Addendum No. 3
March 17, 2025

Project: Brandon Valley Middle School Addition
Brandon, South Dakota
Project #3090

Architect: Architecture Incorporated

DEMOLITION PLAN - AREA D
 SCALE: 1/8" = 1'-0"

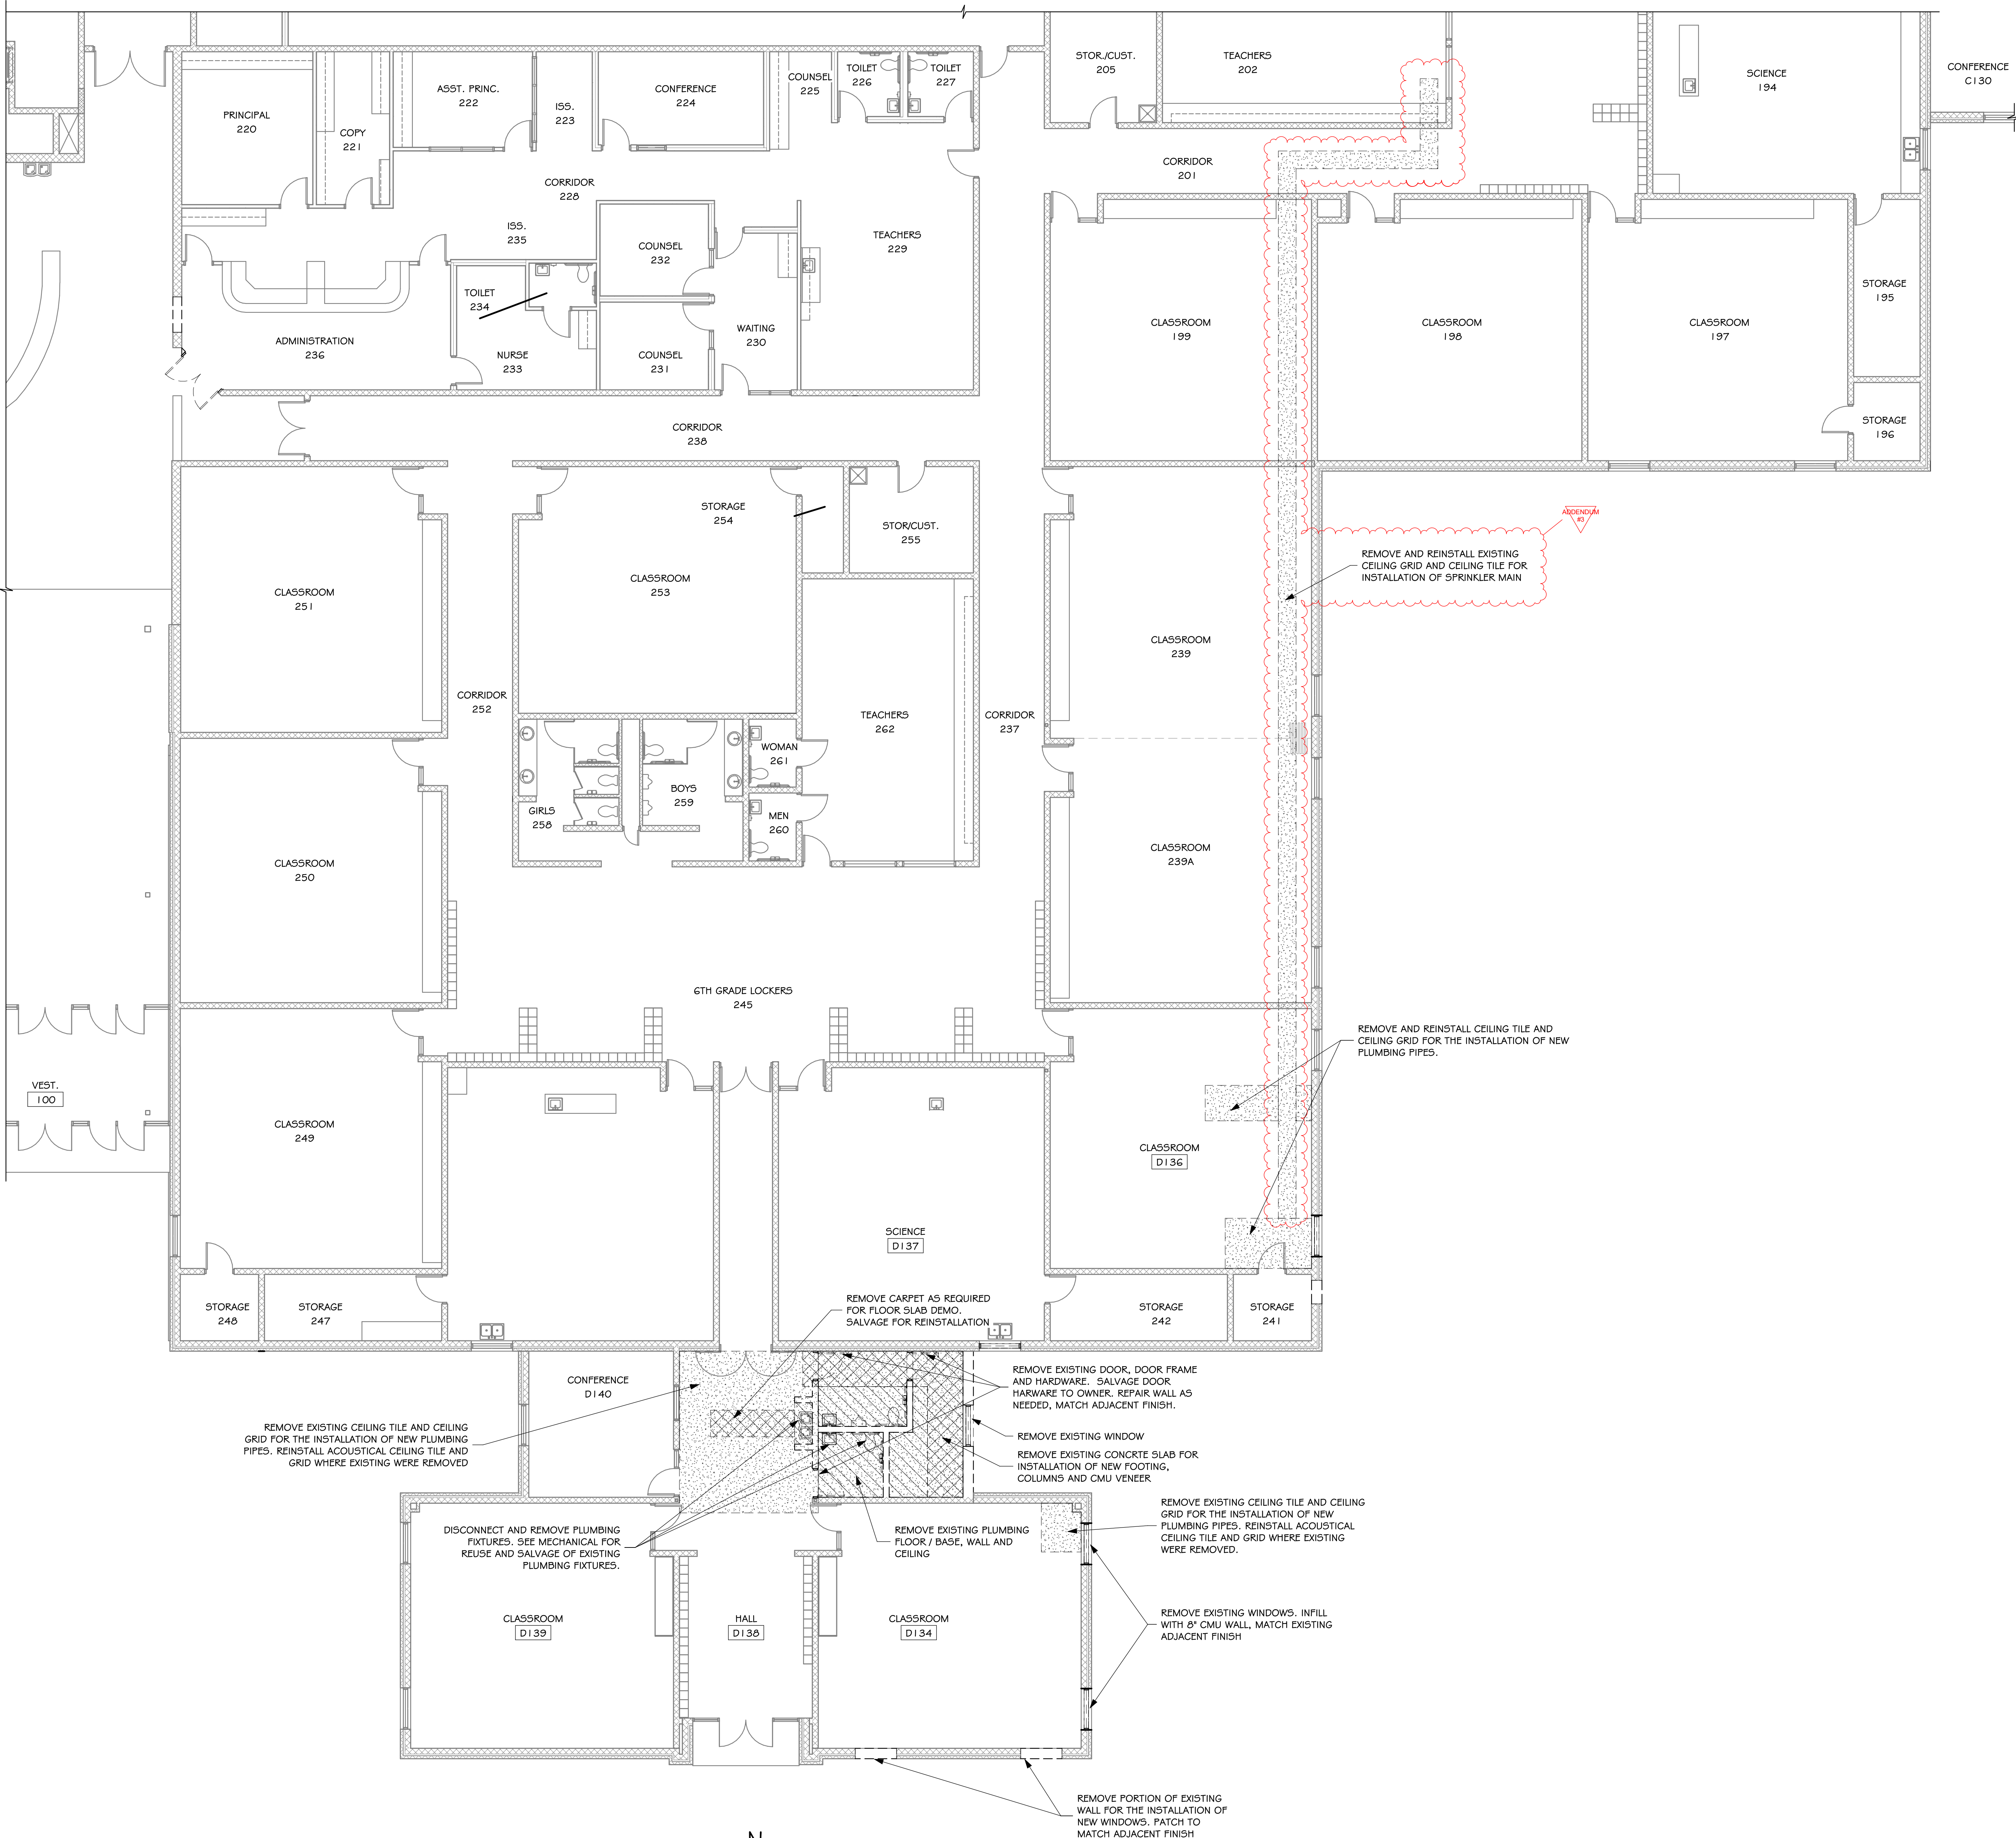
- 3) SHEETS 4.02, 6.10B & 6.10D –DEMOLITION PLAN - AREA D AND NEW REFLECTED CEILING PLANS
 - a) Sheet 4.02: Contractor shall remove and reinstall existing ceiling tile and grid to install new fire sprinkler main as shown on the mechanical drawings.

6.10B

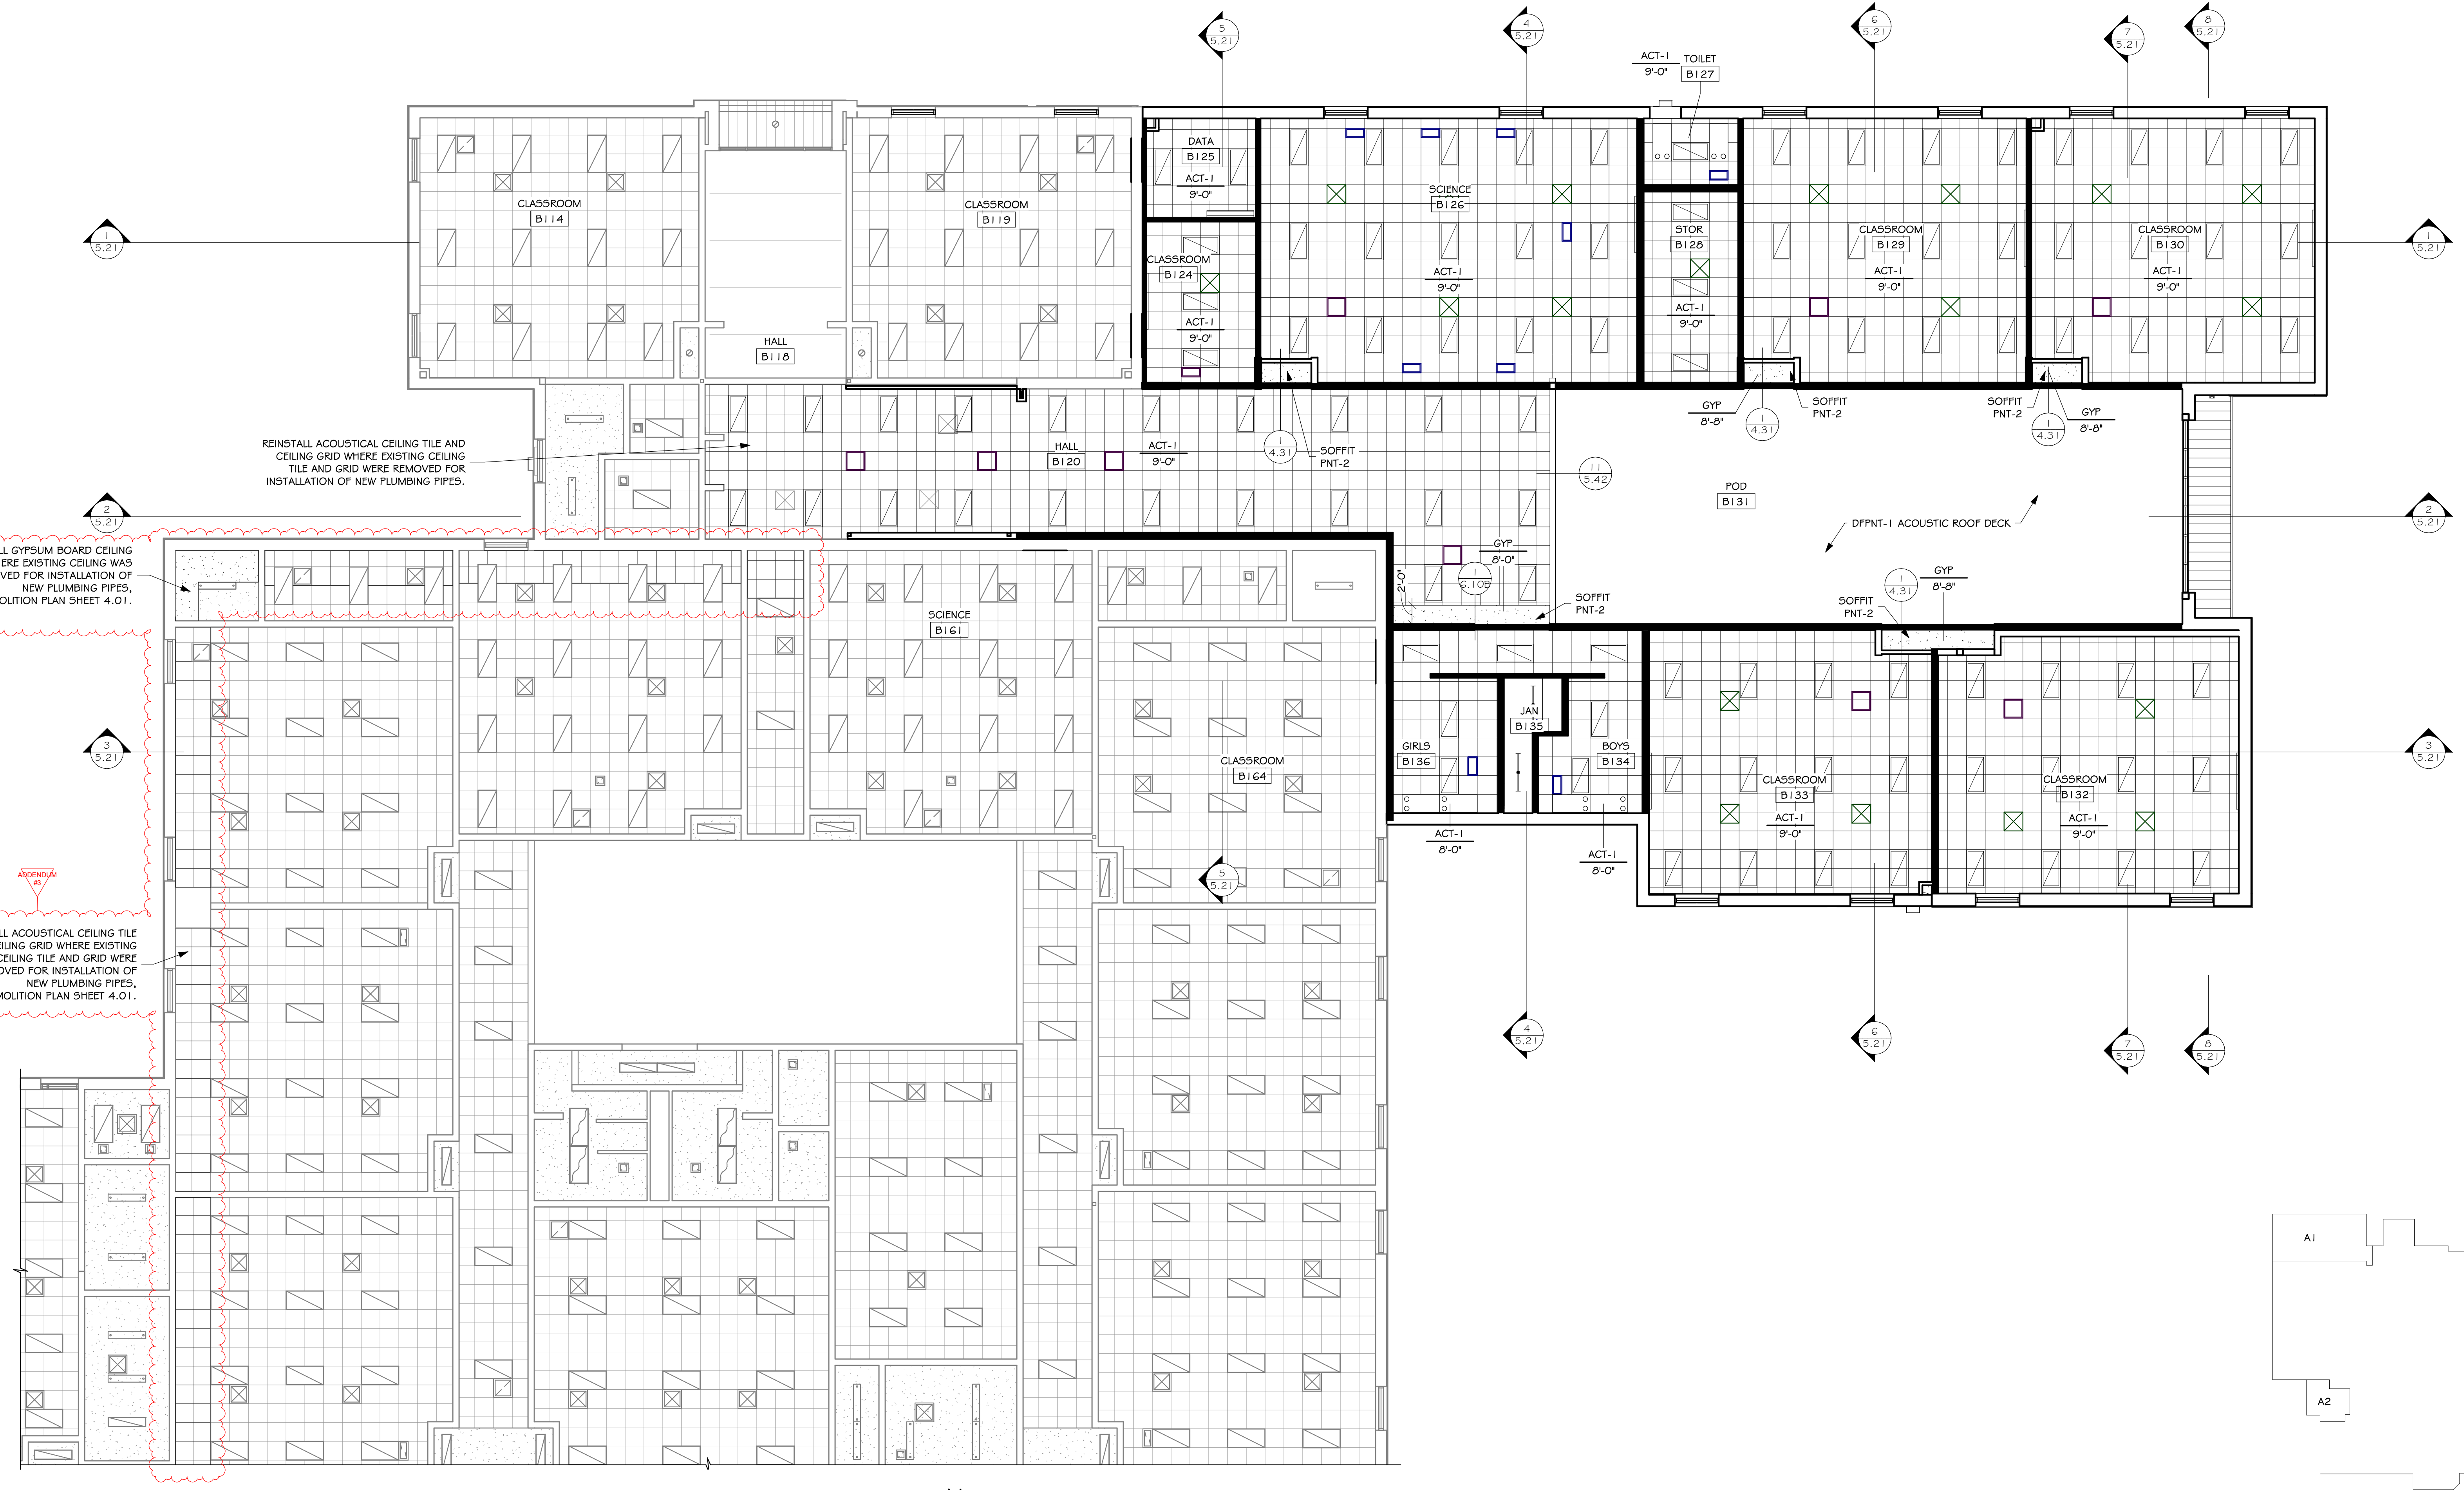
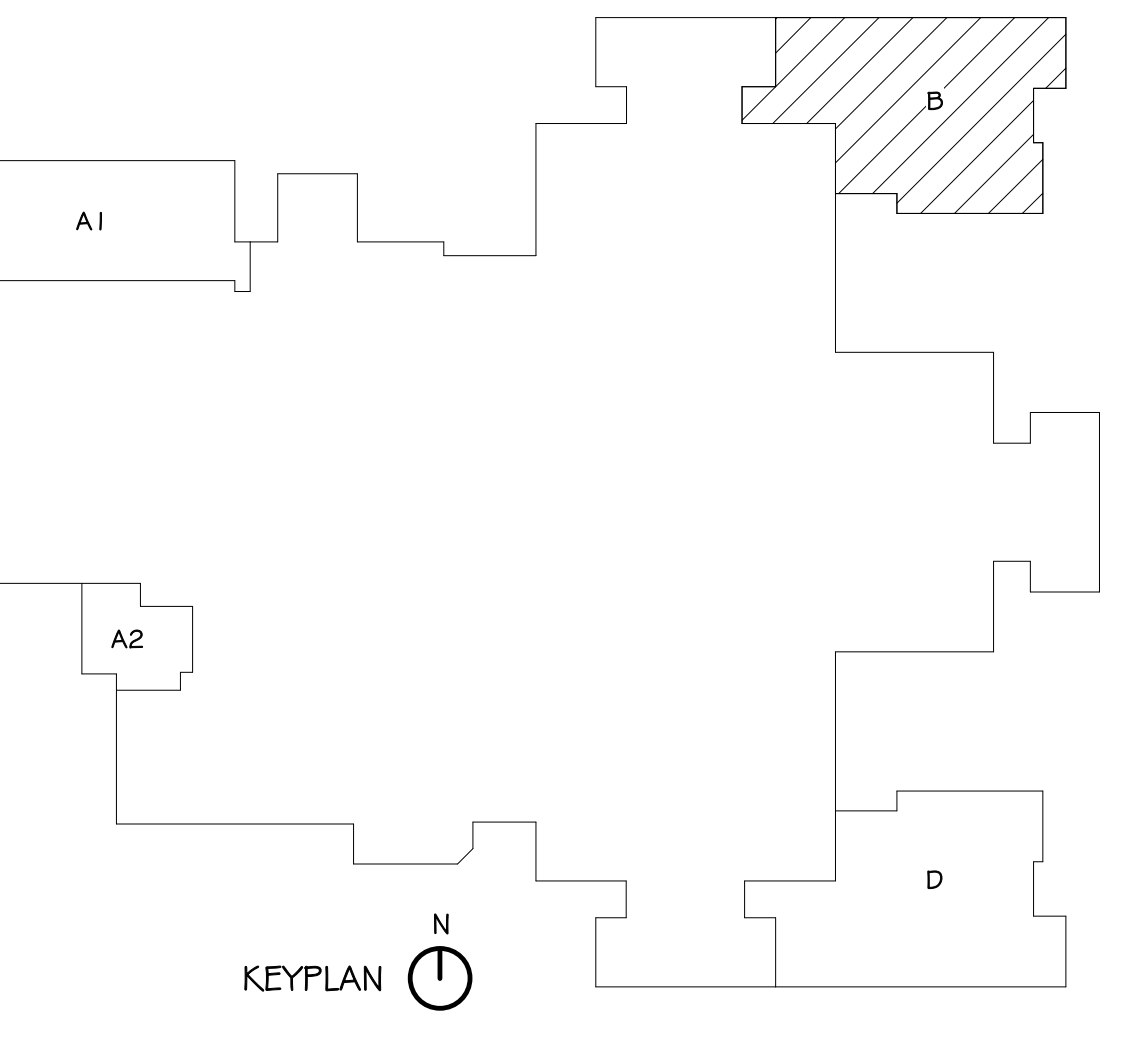
- b) Sheet 6.10B & 6.10D: Contractor shall remove and reinstall existing ceiling tile and grid to install new plumbing heating lines and fire sprinkler lines as shown on mechanical drawings.

APPENDUM #3
 REINSTALL GYPSUM BOARD CEILING WHERE EXISTING CEILING WAS REMOVED FOR INSTALLATION OF NEW PLUMBING PIPES, SEE DEMOLITION PLAN SHEET 4.01.

REINSTALL ACOUSTICAL CEILING TILE AND CEILING GRID WHERE EXISTING CEILING TILE AND GRID WERE REMOVED FOR INSTALLATION OF NEW PLUMBING PIPES.
